4 Mitchell St, Enfield Planning Proposal

Independent Urban Design and Traffic Assessment

Prepared for Burwood Council

July 2018

Figure 14 Concept Plan – north south sections comparison diagrams

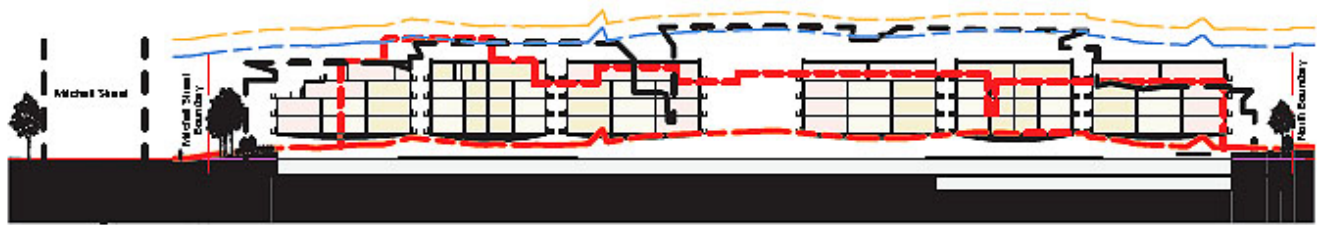
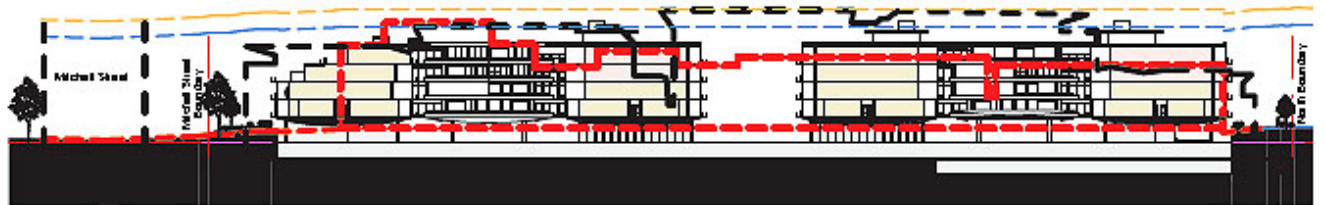
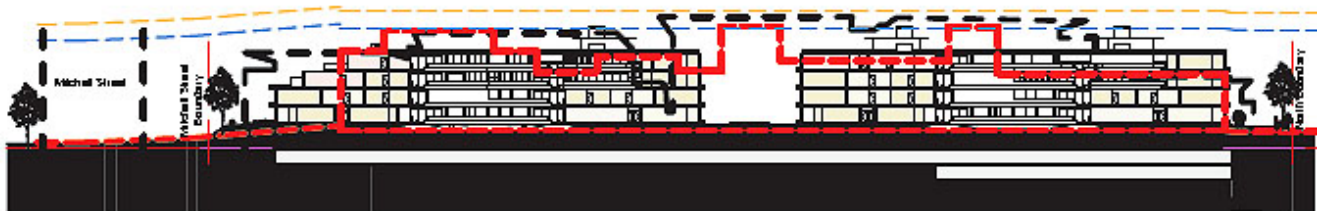
As illustrated on Figures 14 and 15 below, the revised building heights have been formulated to ensure the built forms are no higher than the highest parts of the existing buildings on the Site, with the majority of the building forms being substantially lower than existing and the now proposed 18m maximum height limit, particularly towards the boundaries with adjacent dwellings and Baker and Mitchell St's.
